SUNDRY NOTICES AND REPORTS ON WELLS

8. Well Name and No.
STREETCAR 15 FED 705H 4H

EOG Resources requests an amendment to our approved APD for this well to reflect a change to a 4-string casing design as attached.

Proposed Wellbore
Revised 2/1/18
API: 30-025-42862

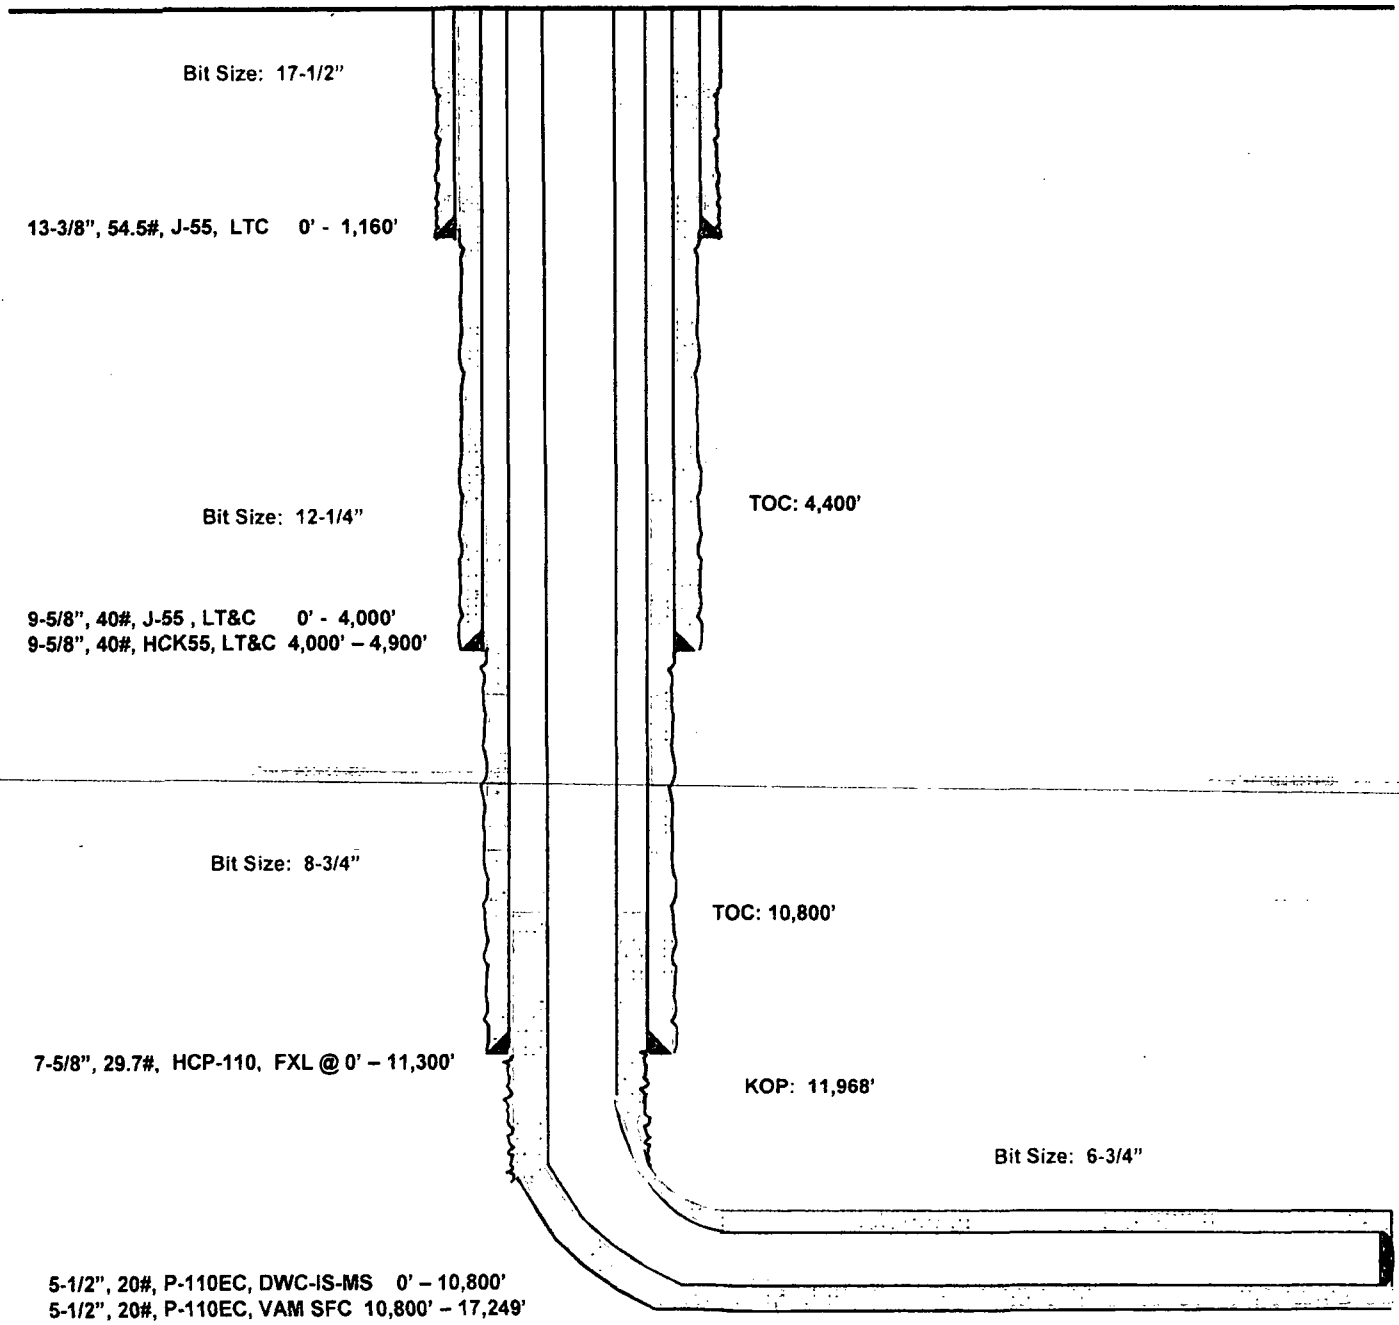
Casing Program:

Hole Size	Interval	Csg OD	Weight	Grade	Conn	DF_{min} Collapse	DF_{min} Burst	DF_{min} Tension
17.5"	0 – 1,160'	13.375"	54.5#	J55	STC	1.125	1.25	1.60
12.25"	0-4,000'	9.625"	40#	J55	LTC	1.125	1.25	1.60
12.25"	4,000' - 4,900'	9.625"	40#	HCK55	LTC	1.125	1.25	1.60
8.75"	0 – 11,300'	7.625"	29.7#	HCP110	FXL	1.125	1.25	1.60
6.75"	0 – 10,800'	5.5"	20#	P110EC	DWC CIS MS	1.125	1.25	1.60
6.75"	0'-17,249'	5.5"	20#	P110EC	VAM SFC	1.125	1.25	1.60

Variance is requested for annular clearance of the 5-1/2" x 7-5/8" to the top of cement.

All previous COA still apply expect the following:

1. The **13-3/8** inch surface casing shall be set at approximately **1160** feet (a minimum of 25 feet into the Rustler Anhydrite and above the salt) and cemented to the surface.

2. The minimum required fill of cement behind the **9-5/8** inch intermediate casing is:
   - Cement to surface. If cement does not circulate see B.1.a, c-d above.**Additional cement maybe required. Excess calculates to 20%.**

3. The minimum required fill of cement behind the **7-5/8** inch production casing is:
   - Cement should tie-back at least 200 feet into previous casing string. Operator shall provide method of verification.

4. The minimum required fill of cement behind the **5-1/2** inch production casing is:
   - Cement should tie-back at least 200 feet into previous casing string. Operator shall provide method of verification.
